HISTORIC AND DESIGN REVIEW COMMISSION

October 18, 2017

HDRC CASE NO: 2017-524
ADDRESS: 302 CEDAR ST
LEGAL DESCRIPTION: NCB 2963 LOT A12 & W IRR 97 FT OF S IRR 9 FT OF A-11, N 8 FT OF E 89 FT OF A13
ZONING: RM-4, H
CITY COUNCIL DIST.: 1
DISTRICT: King William Historic District
APPLICANT: P. Chance Kinnison
OWNER: Stephen Mason
TYPE OF WORK: Replace concrete walkway with crushed limestone
REQUEST:

The applicant is requesting a Certificate of Appropriateness for approval to install crushed granite walkways connecting the front porch, sidewalk, and driveway.

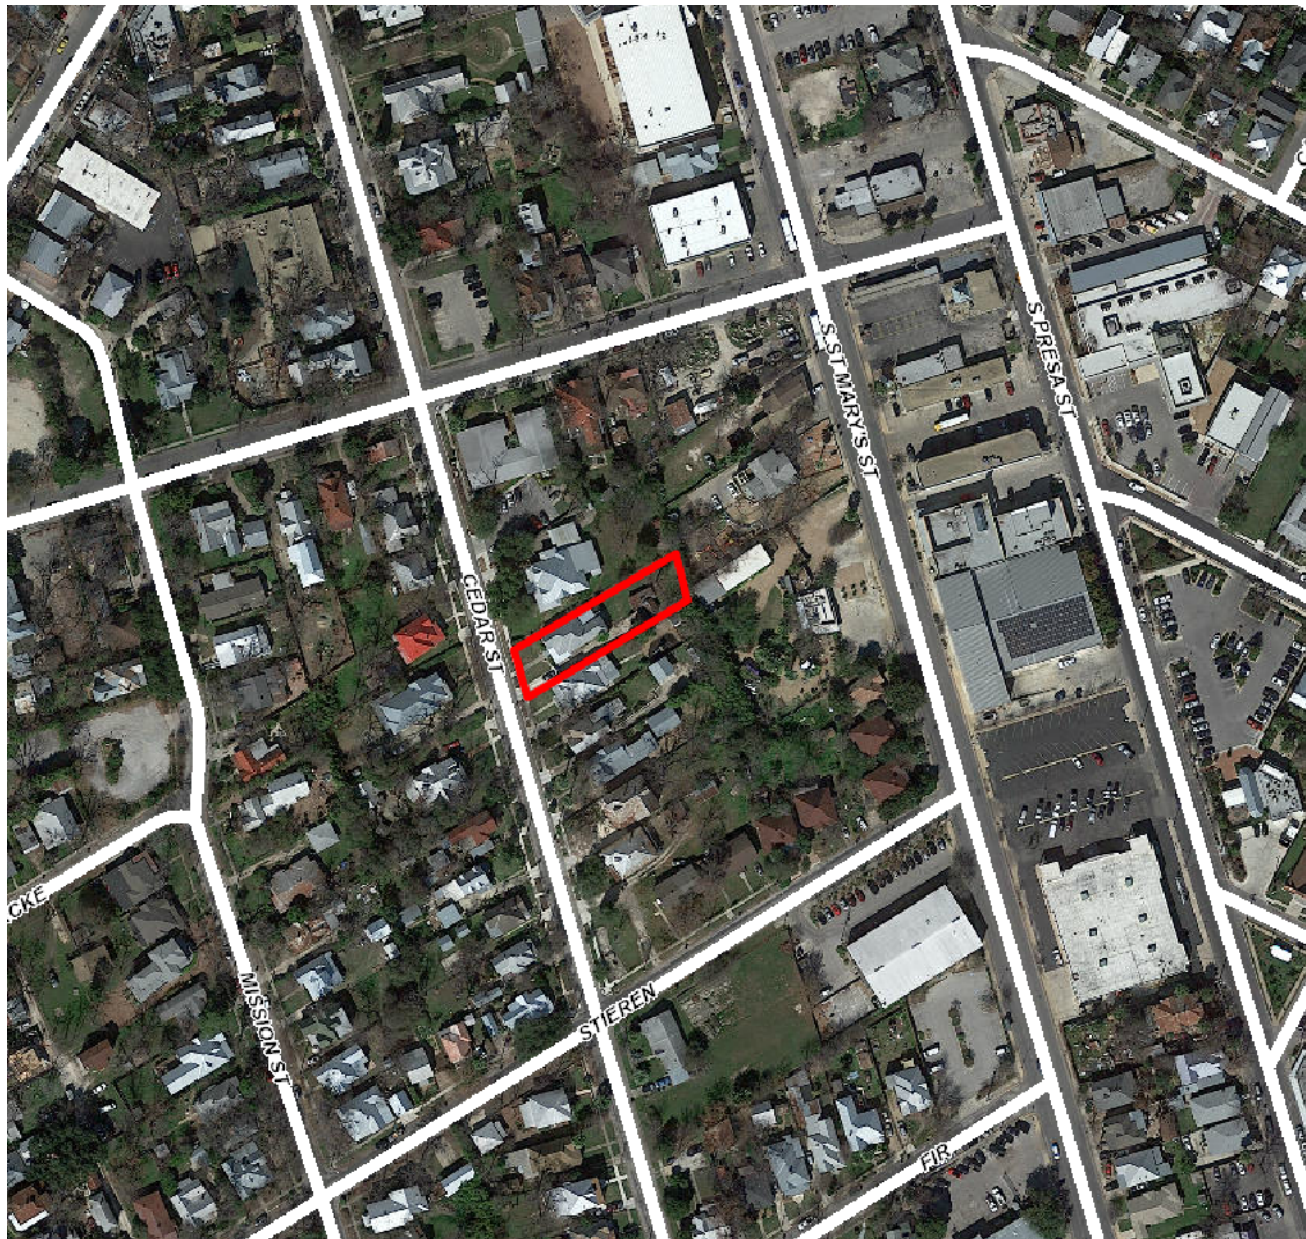
- a. The structure located at 302 Cedar was constructed circa 1907 featuring Folk Victorian architectural elements. The front yard features a concrete walkway connecting the front porch and the sidewalk.
- b. WALKWAY – The applicant has proposed to replace the concrete walkway with crushed granite and to expand the new walkway to the driveway. The Guidelines for Site Elements: Walkways 5.A.i and ii note that historic walkways should only be replaced when deteriorated beyond repair and every effort should be made to match existing sidewalk color and material. Staff finds the proposal to replace the existing concrete walkway with crushed granite not consistent with the Guidelines. However, staff does find the addition of a gravel path to the driveway appropriate.

CASE COMMENT: During a site visit conducted on October 11, 2017, staff finds that concrete walkway has been removed prior to issuance of a Certificate of Appropriateness. Staff recommends the reinstallation of a concrete walkway that matches the one prior to removal.

Staff recommends final approval of both requests based on findings b and c with the stipulation that the existing walkway remains concrete.
